Springwell Solar- Written Representations for Deadline 1

by Anne Heard (Interested Party Reference 20054475)

Fig 1

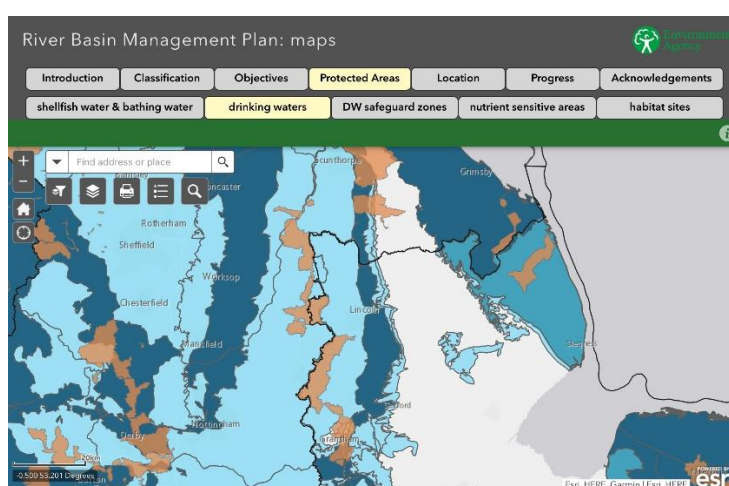
1.2 The proposed Springwell BESS is on the Lincolnshire Limestone aquifer which is a “high risk” drinking water protected area as shown on the Anglian River Basin District River Basin Management plan produced by the Environment Agency and updated 2022 (Fig 1). (The River Basin Management Plan is made in accordance with the Water Framework Directive which originates from the European Union but which has been incorporated into English Law by the Water Environment (Water Framework Directive) Regulations 2017). Paragraph 7 of the plan states that hazardous substances must be prevented from entry into groundwater.

Fig 2

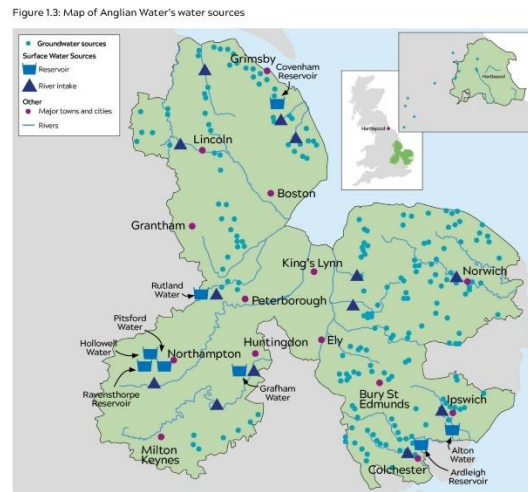
1.3 The Anglian Water Drought Plan (April 2022) states that Anglian Water provides water or wastewater services to more than 6 million customers. Paragraph 15.2 states that Anglian Water abstract water from a combination of groundwater and surface water sources, supplying over 1,100 million litres of water per day; that 50% of the supply is provided by groundwater extracted from 200 sources comprising over 450 operational boreholes. The principal source of groundwater is from chalk but includes Lincolnshire Limestone. Figure 1.3 of the plan shows the map of Anglian Water water sources, with the line of boreholes running south from Lincoln along the Lincolnshire Limestone (Fig 2). The proposed Springwell BESS lies on the line of these boreholes.

Fig 3

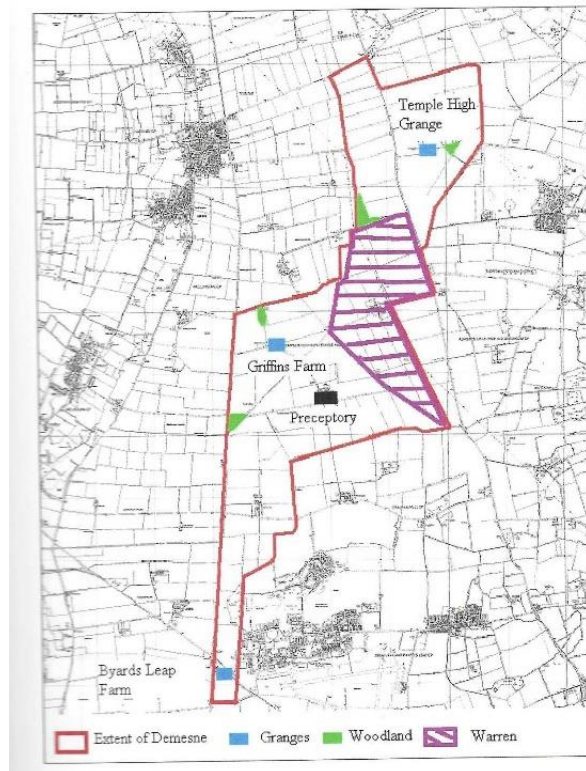
8.1 The practice of the Knights Templar was to consolidate their land holdings to produce compact units of demesne land that provided the setting for a planned landscape around their Preceptories. Nineteenth century maps show the extent of tithe free land around Temple Bruer constituting the core of the Templar estate. In Heard A. (2008) *The Knights Templar in Lincolnshire* Unpublished PhD thesis York University, Fig 4.3 indicates the way that the Templars may have organised their demesne lands at Temple Bruer with the Preceptory at the centre of the estate and granges strategically placed to enable them to work the surrounding fields. Within the estate were areas of woodland, the timber forming a valuable resource for the Preceptory and a rabbit warren on the heath, a symbol of high status and an important element of the designed landscape around the Preceptory.

Fig 4

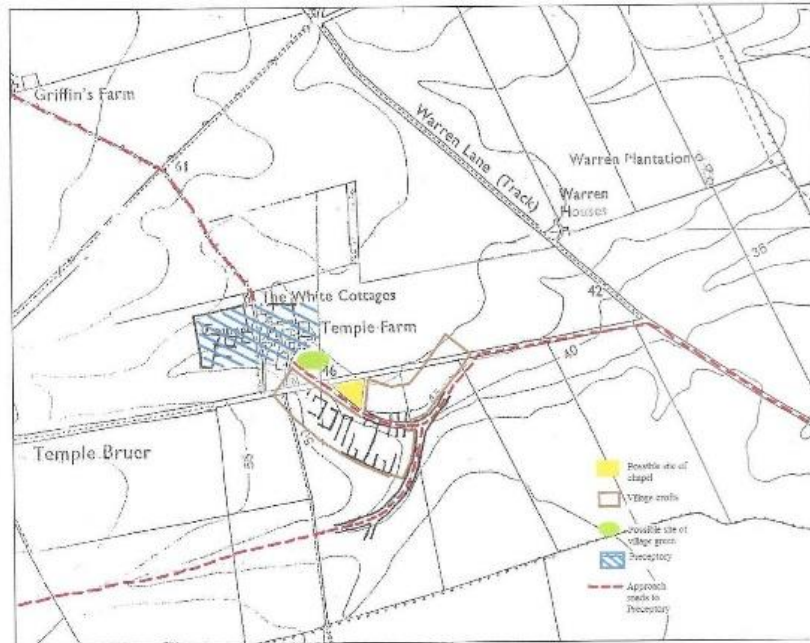
8.2 Part of the designed landscape of the Preceptory was the attendant planned settlement. The main approach road to the Preceptory from the east off what is now the A15 would have joined with the road from Ermine Street to the west and then continued to curve around the uniform sized village tofts either side of the road leading past a village green and on to the gatehouse of the Preceptory. This processional route would have reinforced to visitors the elite power of the Templars

as landowners in the medieval landscape. Fig 4.9 of the thesis shows these approaches to the Preceptory:-
